## **THE BAY RESORT, ANNA BAY OBJECTION**

**6/5/2021**

Review of the amended EIS still highlights many areas of concern for the proposed “The Bay Resort, Anna Bay.”

**Figure 23 Proposed upgrade of Nelson Bay Road intersection**  
(Source: Northrop Consulting Engineers)

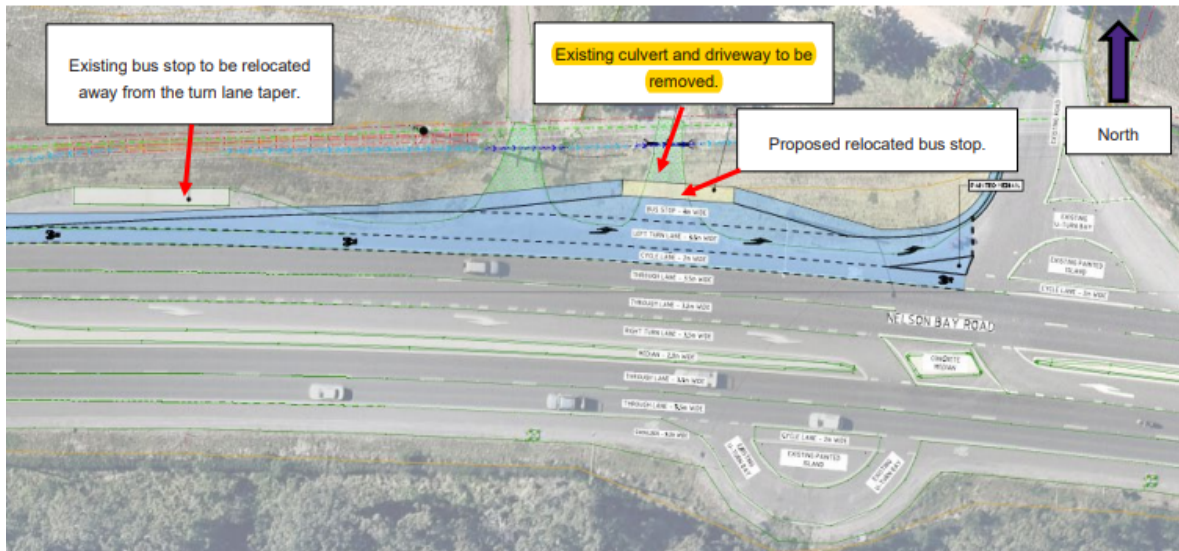
Comment: This upgrade denies legal front access to property 4181 Nelson Bay Road. This access has been in use since 1984. This again shows no consideration to adjoining landowners and the lack of technical expertise exercised, consultation or care in developing the proposal.

**Figure 18 Viewpoints selected for analysis.**

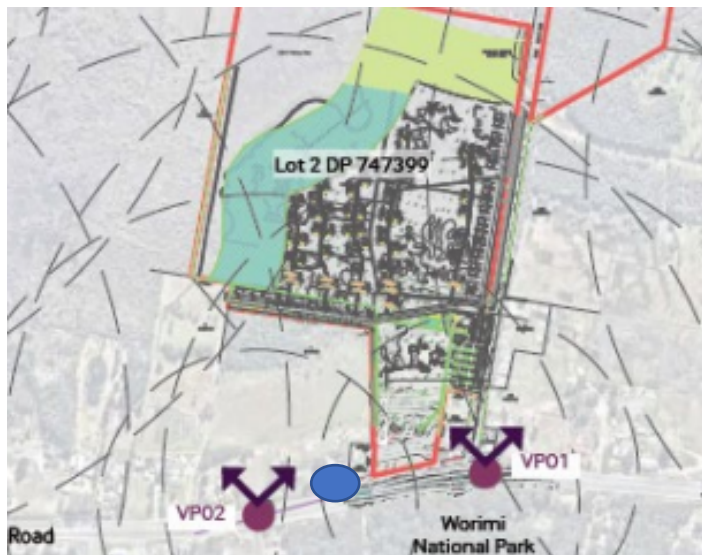
View-Point 1 is not in correct position on the location map, therefore it gives a misleading perspective. The blue dot shows the actual position the supposed views at View Point 1. The views represented are completely different from those that would be obtained at VP01.

View-Point 3 and 4 are 2km away from proposed site.

View-Point 6 is 1.5km from proposed site.

View-Point 5 is 5km from site.

View-Point 3,4,5 and 6 are all shielded by vegetation and topography from proposed site.

There are no view-points from adjoining rural properties ie 4165, 4181, 4183, 4187 Nelson Bay Road. These will be the most visually affected and their visual amenity dismissed.

#### ESD - Amended EIS

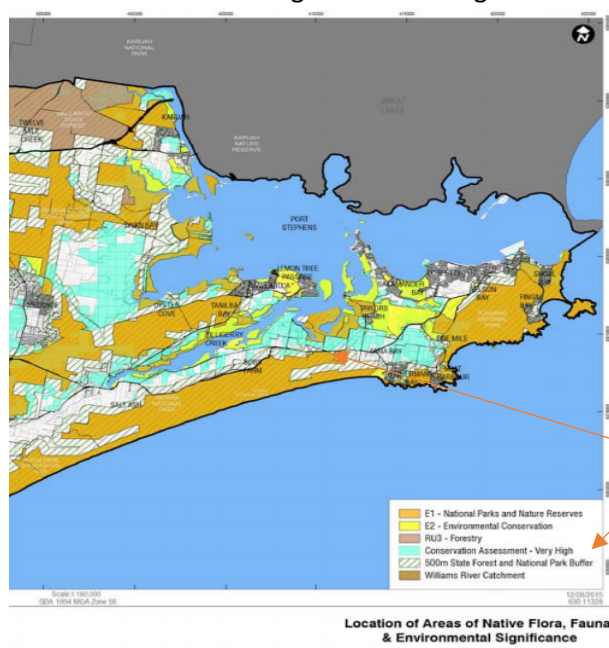
- Targets will be set on completion of an energy model to see what may be realistically achieved for this type of development. Subject to targets, attention will be given to the issues and actions required to achieve these targets. This would include “deemed to satisfy” energy code compliance requirements as a minimum. It may also include the need for design workshops and modelling input. This should guide the design to achieve the nominated targets. Post construction monitoring will be provided to ensure the buildings operate as designed.

Comment: Should not an eco-tourist development have these targets for eco sustainability already set and these targets be transparent in the EIS?
